<b>R E P O R T</b>	<b>TO</b>	Hearings Committee
	<b>FROM</b>	Joe Gray Consultant Planner
	<b>FILE REF</b>	RC-15521 / 427422
	<b>DATE</b>	13 August 2008
	<b>SUBJECT</b>	<b>Application to subdivide Lot 1 DPS 24715 into two residential lots. D &amp; L Fairgray – 5 Moray Place, Whiritoa</b>

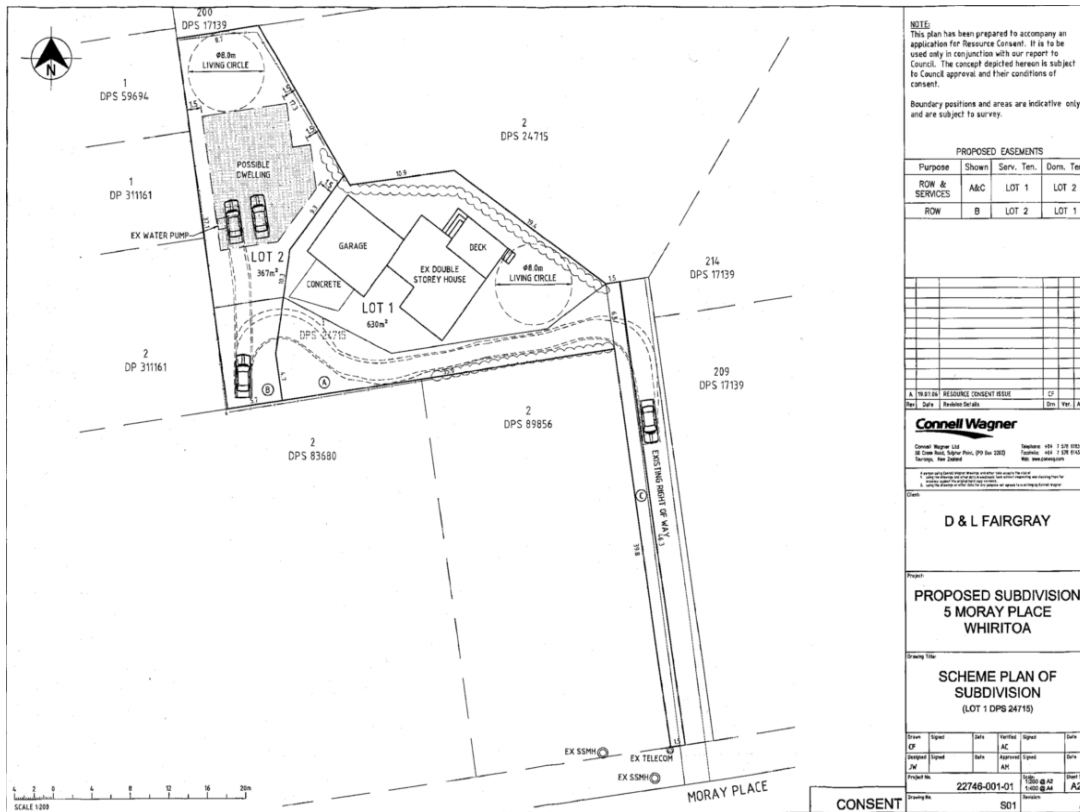
- The existing hedge adjoining the north eastern boundary of the access leg is located within the subject property. It is recommended that this hedge be removed and a thin fence be erected on the boundary. This will provide sufficient manoeuvring space and is considered to be more appropriate than allowing an eaves easement. It is considered that the access leg can be locally reduced to 3m at the northern most point of the access leg so that the eaves are contained entirely within proposed Lot 1.

The proposed subdivision will result in four lots obtaining access to the existing Right of Way which is currently approximately 4.56m wide and 56.75m long. Rule 9.3.19 of the District plan stipulates that any Right of Way serving 4-6 lots shall have a minimum width of 6m, minimum carriageway of 4.8m and a maximum length of 40m.

The existing Right of Way is 56.75m and the proposed shared Right of Way (marked as 'A' on the scheme plan) will be 13.64m. The proposed subdivision will therefore result in a total Right of Way length of 70.14m.

As noted, the applicant wishes to establish an eaves easement over Lot 1 in favour of Lot 2 in order to provide a complying accessleg width. However, Council's Consents Engineer has noted that the existing hedge adjoining the access leg is located entirely within the subject property and can be removed. It is therefore recommended that a condition be imposed (if consent is granted) requiring that the hedge be removed. Council's Consents Engineer has recommended that the width of the access leg should be locally reduced to 3m at the northern most section of the access leg so that the eaves are contained entirely within proposed Lot 2.

Proposed Lot 2 is unable to provide a complying 10m x 15m rectangle for site development purposes. Any effects associated with this are not considered to be any more than minor as there is an existing dwelling on the property. Lot 2 can still provide a complying living and service court and a possible garage toward the southern boundary of the subject property.

11. That the existing hedge located on the northern boundary of this development shall be removed over the extent of the proposed ROW (A) and the proposed access leg for Lot 1.

12. That the existing garage and deck within Lot 2 shall be cut back or removed to ensure that no part of the deck is located within the Lot 1 access leg and that the garage is clear of the 1.5m yard requirement.

13. That the proposed access leg width for Lot 1 be locally reduced from 3.5m to 3.0m at the northern most section of the access leg.
14. That Right of Way 'A' shall be constructed in accordance with the standard for a Right of Way serving 1-3 lots in the Residential Zone, as outlined in Rule 9.3.19.3 of the District Plan.

15. That the following design measures shall be implemented for the upgrading of the existing Right of Way:
  - a) That the existing Right of Way paved/ hard surface area width be widened to the full existing legal width of 4.56m using gobi blocks.
